CASE NO. 868-S-17 and 874-V-17 SUPPLEMENTAL MEMORANDUM #2

Petitioner: Topflight Grain Coop, Inc. via agent Scott Docherty

DRAINAGE BASIN: AS-DESIGNED VS. AS-BUILT

Volumn Calculations - End Area Method

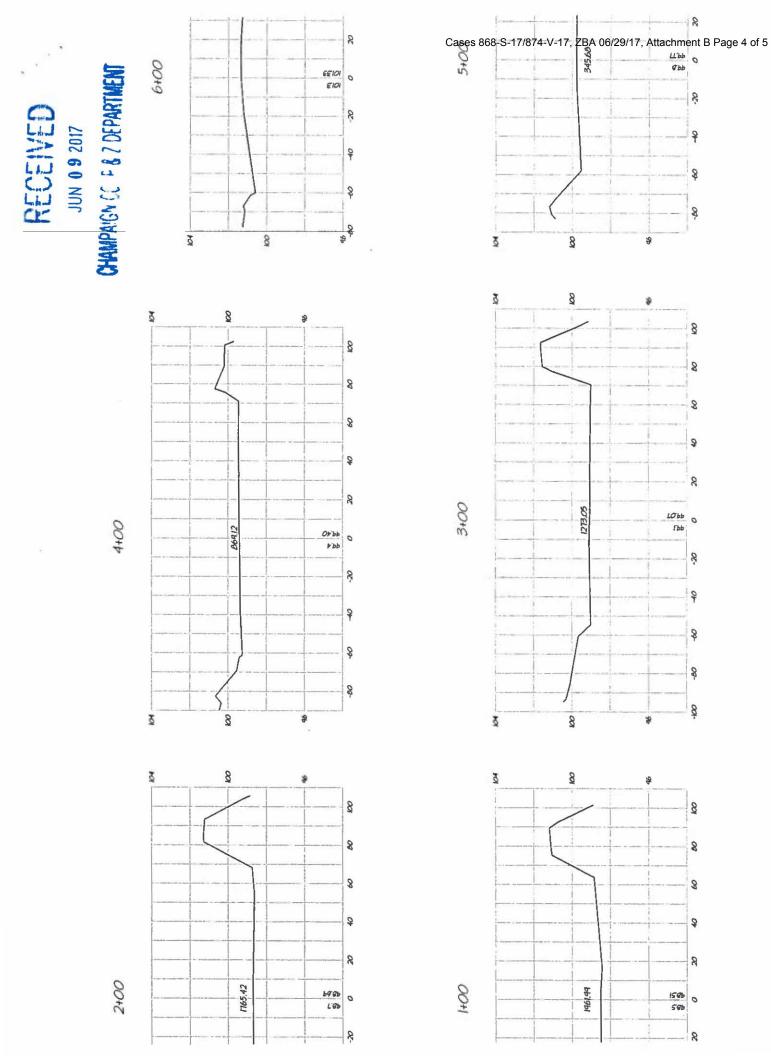
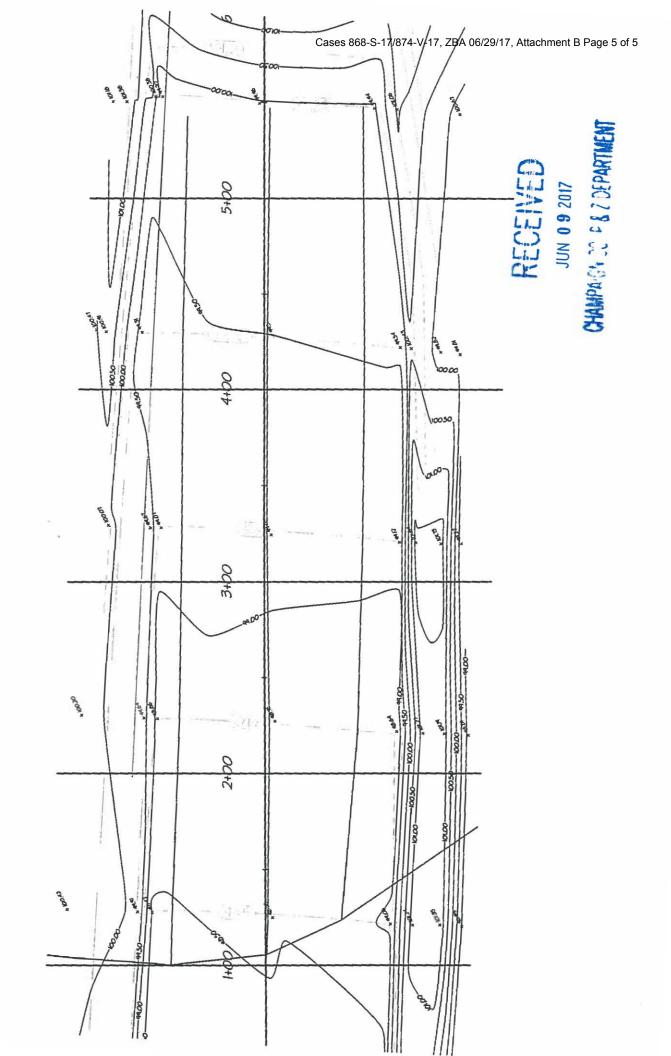
It looks like page 2 of the document you sent (attached) may have been cut off. Could I bother you to check that and resend?

Also, on page 1 (volume calculations), you have a total of 506,142.5 cubic feet. That volume seems extraordinarily large, and I just wanted to see if you could verify that/let me know if you stand by that figure.

I did not do these calculations, but here is what I think I have figured out. The page 2 is cut off, but I think they cut it off on purpose because it shows only the area where they were computing the volume. On the calculations on page 1, I believe that the areas are too high by a factor of 10. If this is true, it is because the vertical scale on the sections is 10 times the horizontal scale and they forgot to factor that in to the result. I believe that the total volume should be 50,614 cubic feet, not 506,142.5. Hopefully this helps. Let me know if there is anything else you need us to do.
